**State Significant Development Application SSD-11606719**  
**Site: Lots 1 & 2 DP 1145808, Lot 2 DP 1247691 and Lot 7 DP 1200048**  
**Submission on behalf of Jacfin Pty Ltd**

We act for Jacfin Pty Ltd (**Jacfin**).

We refer to State Significant Development Application SSD-11606719 (**Application**), by which Bingo Industries (**Bingo**) seeks consent to increase the total waste throughput at its Eastern Creek Facility (**Facility**) by 950,000 tonnes per annum (**tpa**) over two stages to a total of 2.95 million tpa, and carry out infrastructure upgrade works across the Site.

Figure 3-1. ST Mary's OEH annual 2016 wind rose (left) compared to the AQIA predicted wind rose at the Project site (rhs). The Project site wind rose should be much more similar to St Mary's than shown.

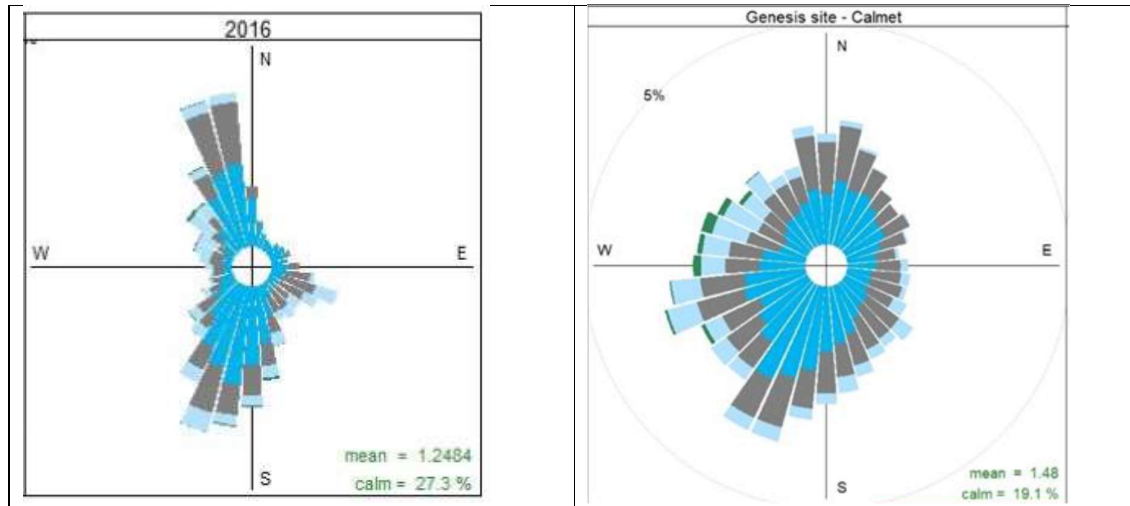
1. The CALMET model domain size at 60 km x 60 km is too large and is inappropriate for the application site. In order to use such a big model domain the AQIA has had to compromise on using a coarse grid resolution of 500m, instead of a much finer grid resolution of between 150m and 250m. The consequence of such a coarse grid resolution is that the land will appear flat, the pit will disappear and the land use will be inaccurate.
2. The wind regime around the Project site is influenced and directed by the local topography. This is the case as can be seen by the St Mary wind rose in Figure 3-1, which shows topographic channelling as the site is located in a north-south valley. The Project Site is located approximately 5km to the east of St Mary's and is also surrounded by the same topography as St Mary's and located within a small north-south valley. Yet, the Project site

wind rose is uniform with winds coming from all directions. The net result of this is that the winds at the Project site do not reflect the terrain around it, and the uniformity of the winds means the pollution load is spread 360 degrees around thereby decreasing the pollution loads and concentrations in the direction of the dominant occurring winds.

3. The number of predicted calms (winds < 0.5 m/s) at the Project site have been underestimated in the AQIA model by at least 7-10%. Figure 4-5 of the Ramboll, 2018 report which compares the predicted wind rose at Badgery creek with observations shows that Badgery Creek records 7.4% calms whilst AQIA model at the same location predicts 0 calms. (Badgery Creek data has been verified from the BOM data, 2013-2015).

4. In Figure 4-6 of the Ramboll report the predicted winds at the Project site are compared with Prospect weather station, 8km to the east. Figure 4-6 shows that the actual data processed in the making of the wind rose, automatically produces a record of the calms in that data set. The program recorded 0% calms at the Project site and 0.1% calms at the Prospect weather station. However, the report contradicts the information on Figure 4-6 and states that the Project site has 19% calm versus Prospect station which has 10% calm. ASG has been able to confirm that the BOM Prospect site does record 10% calms from data examined from 2013 – 2015.

Figure 4-5 and Figure 4-6 confirm that the AQIA model does not predict any calm wind events at the Project site, even though the nearby observation stations record at least 10% of an entire year is calm. Therefore, at a minimum the Project site has 10% calm events which have not been modelled. The consequence of underpredicting the number of light wind events is to underestimate the predicted ground level concentrations.

Figure 4-1. 24-hour average concentration isopleth plots for PM<sub>10</sub> (top) and PM<sub>2.5</sub> (bottom) are shown for Ramboll (2018) (lhs) for Mod 6 approval of a 2 Mtpa throughput and the AQIA (2022) (rhs) for Mod 10 approval for a throughput of 2.95 Mtpa.

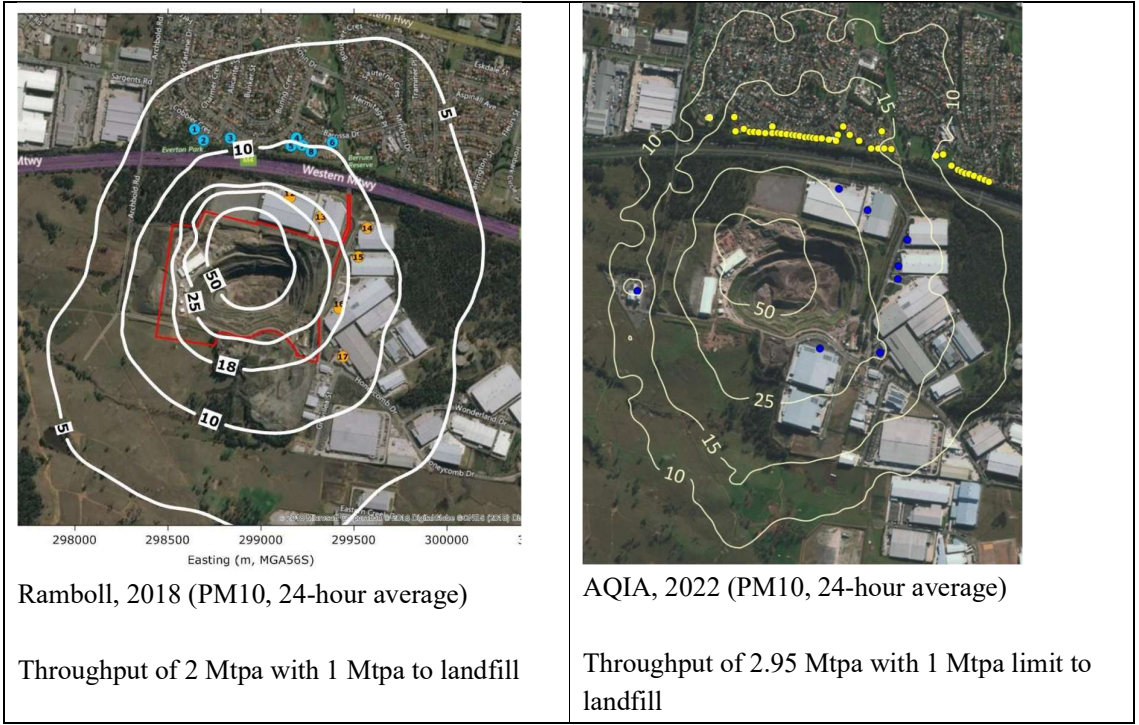
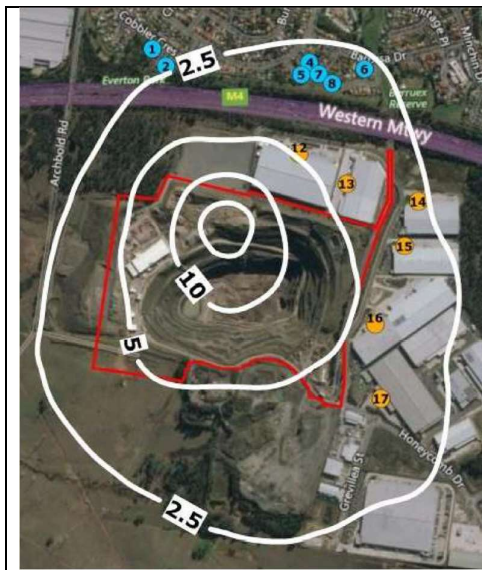
Figure 4-1 presents the concentration isopleth plots for the predicted PM<sub>10</sub> (top) and PM<sub>2.5</sub> (bottom) from the Ramboll (2018) report for 2 Mtpa of material on the left hand side and 2.95 Mtpa of material from the AQIA (2022) on the right hand side. The 10 µg/m<sup>3</sup> isopleth contour plot in the AQIA for the 24-hour PM<sub>10</sub> extends northward compared to the same Ramboll, 2018 contour plot. This is expected as concentrations are expected to be greater and extend further for an additional handling of 950,000 tpa of material.

However, the concentration isopleth plots for PM<sub>2.5</sub> show a different pattern where the AQIA is predicting lower PM<sub>2.5</sub> concentrations for an additional 950,000 tpa of material compared to that predicted by Ramboll, 2018. A comparison of “commercial receptors” between the two reports (as shown in Table 4-1 below) shows that the AQIA is predicting lower concentrations of PM<sub>2.5</sub> for an additional 950,000tpa of material. This is not possible. If PM<sub>10</sub> predictions for the Proposal are higher so will PM<sub>2.5</sub>.
